# **MEMORANDUM**

SUBJECT: Historic Area Work Permit #1050176 - Storm Windows

Address: 7111 Cedar Ave., Takoma Park

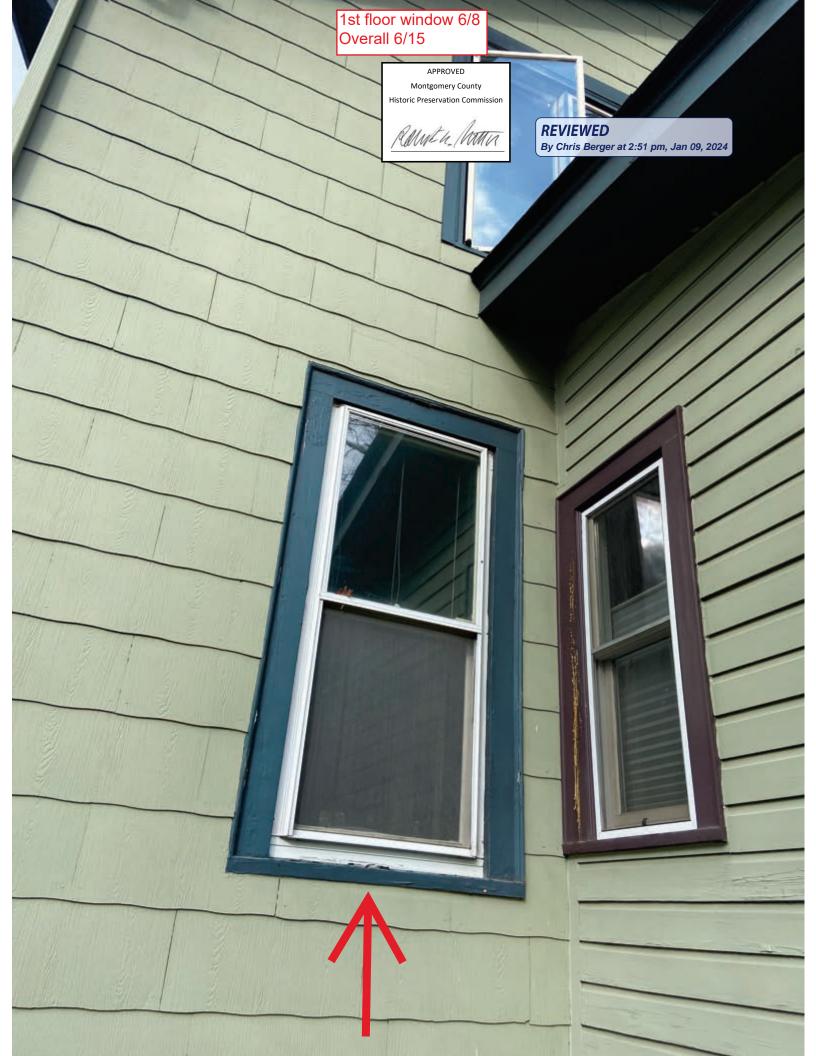
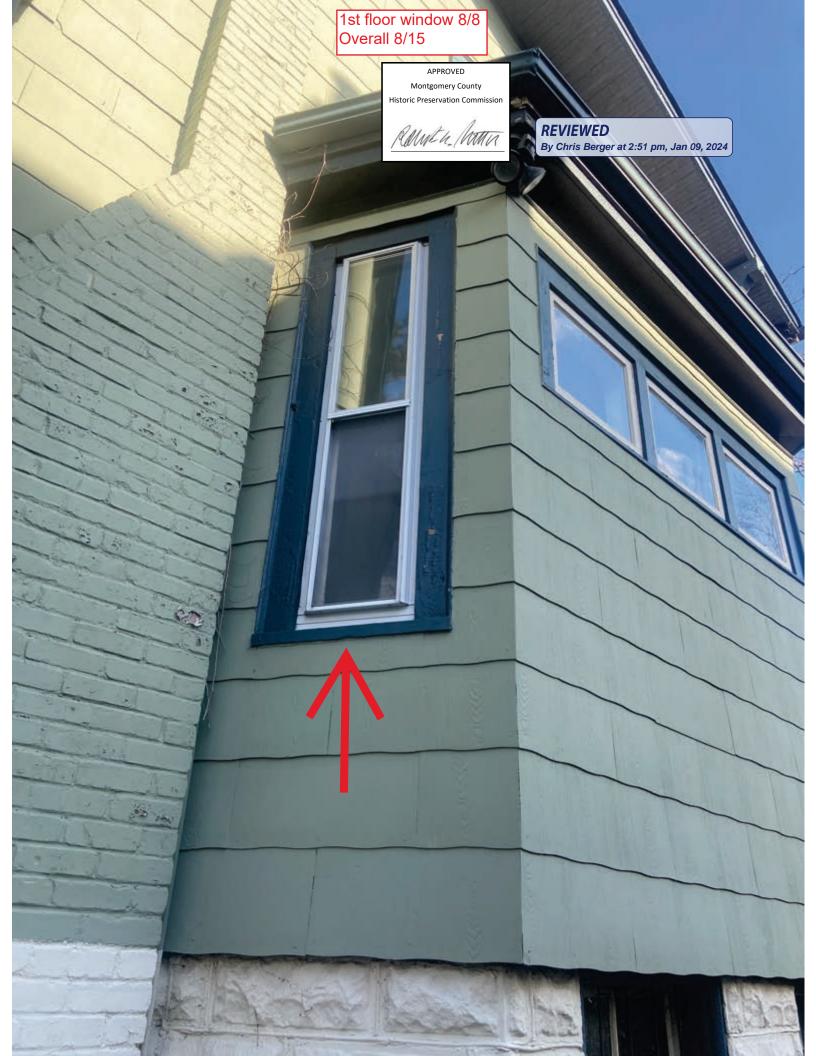
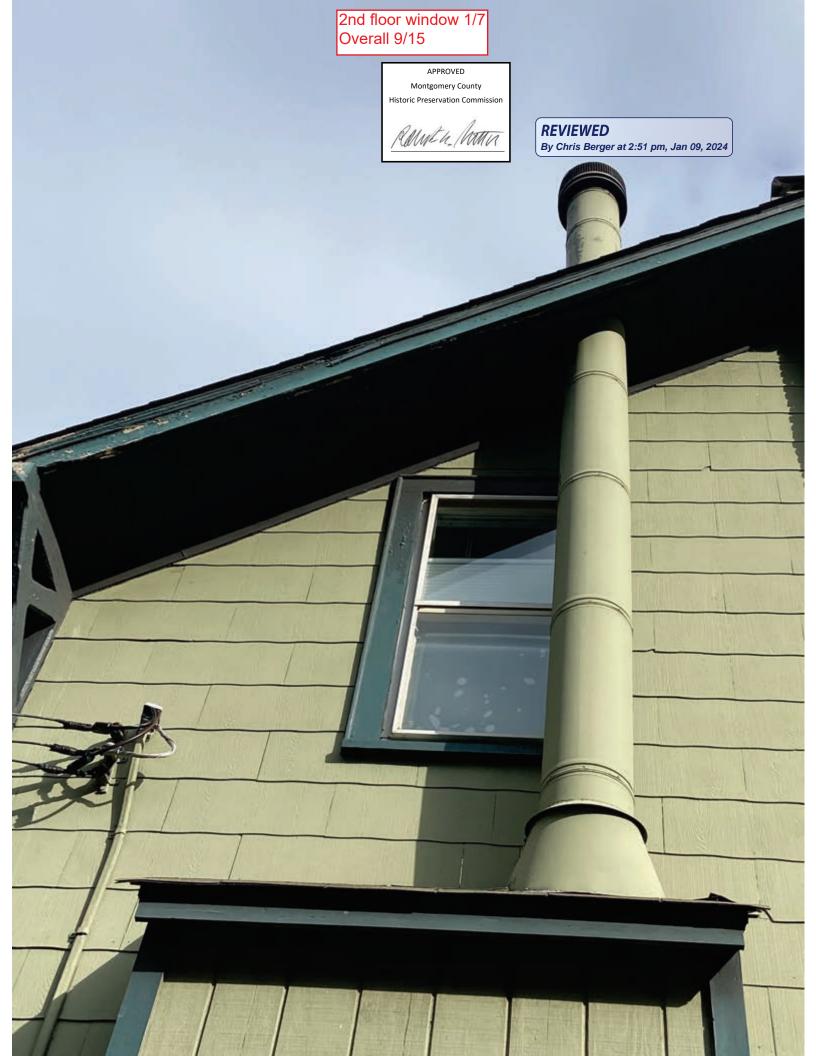
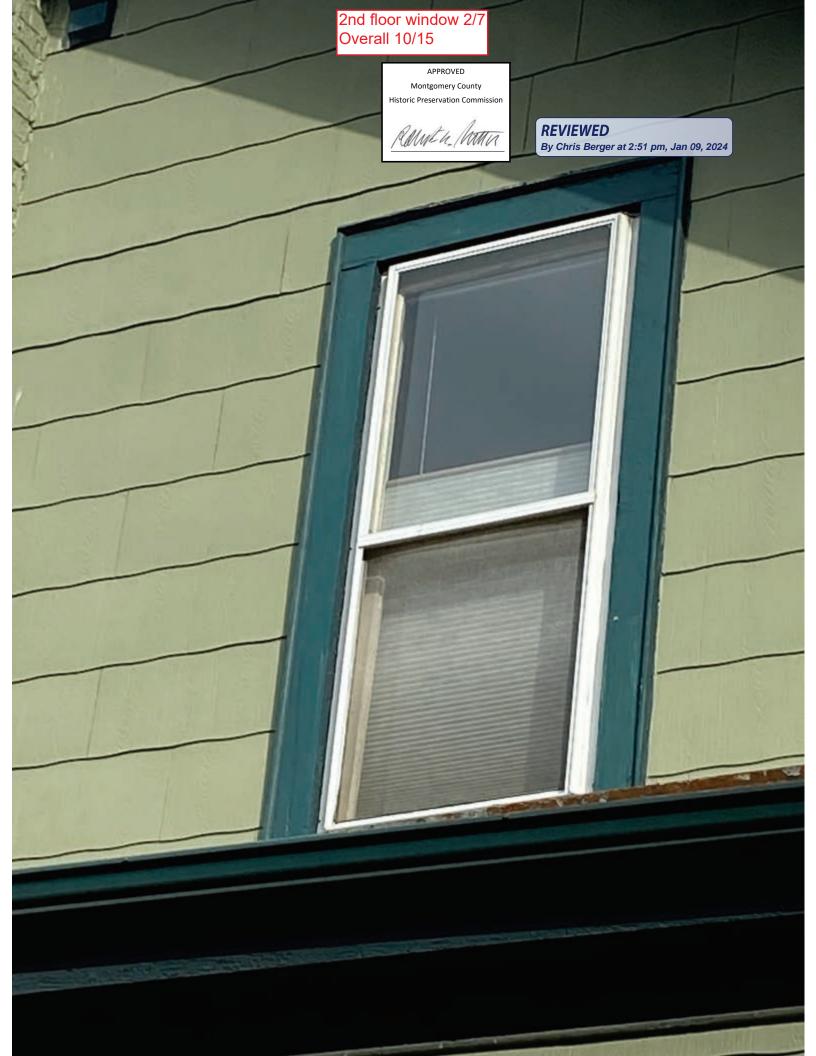
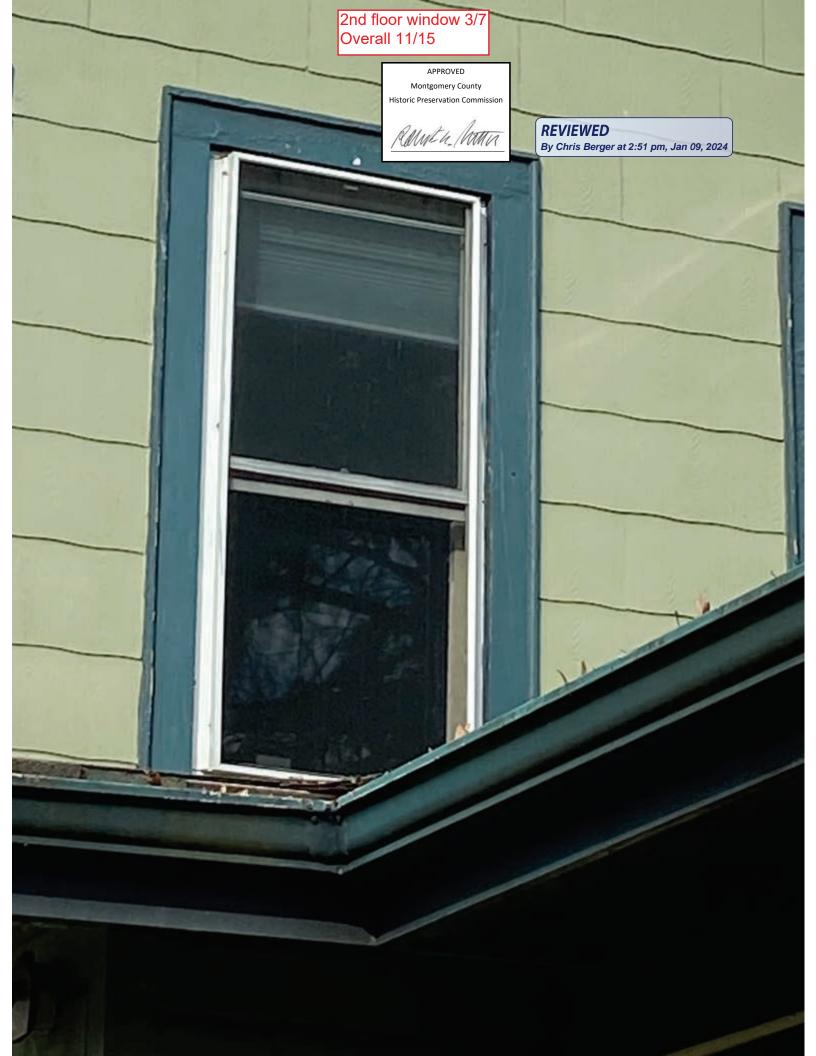
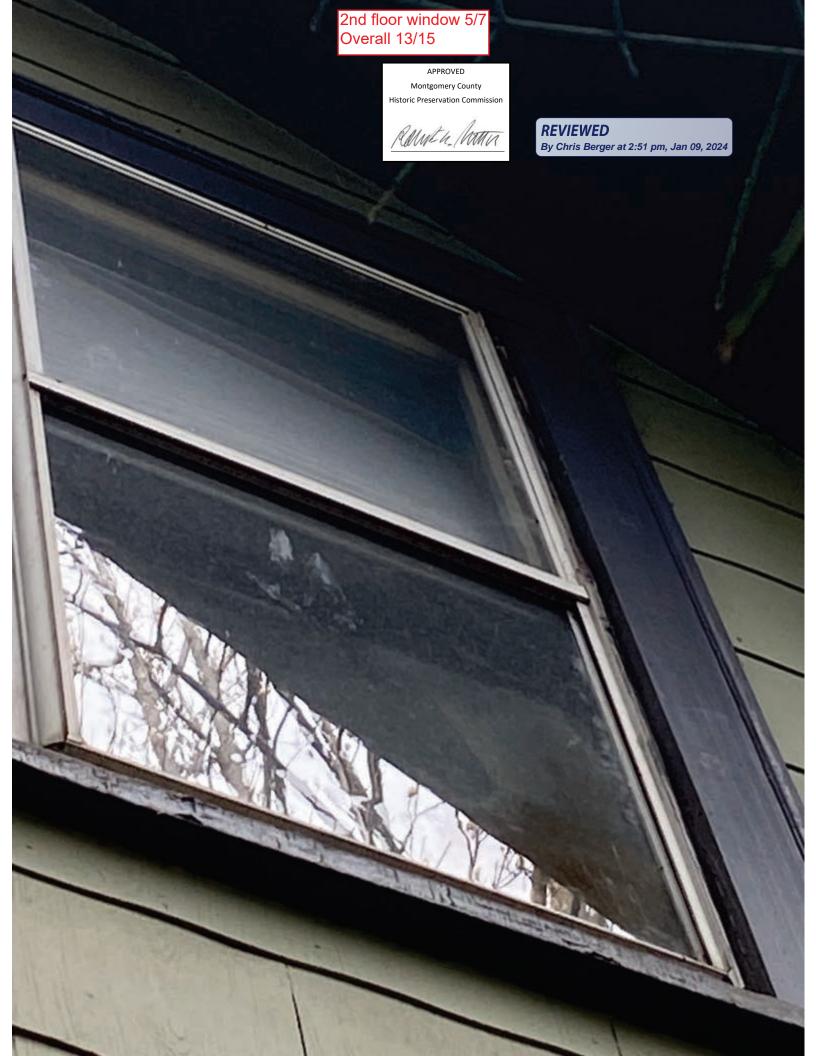
Thanks for the photos. I compiled them and numbered them. Let me know if the windows are labeled correctly.

According to Rick Leonard, 8 storm windows will be installed on the 1<sup>st</sup> floor and 7 on the 2<sup>nd</sup> floor (see his measurements attached). Before we can approve your application, we need photos from the outside of all of the windows where the new storm windows will be installed. Can you take exterior photos of each of those 15 windows, number them, and email them to me? I could also come out and photograph the windows but you would then have to mark up my photos. Let me know your preference.

Looks ok. Thanks.
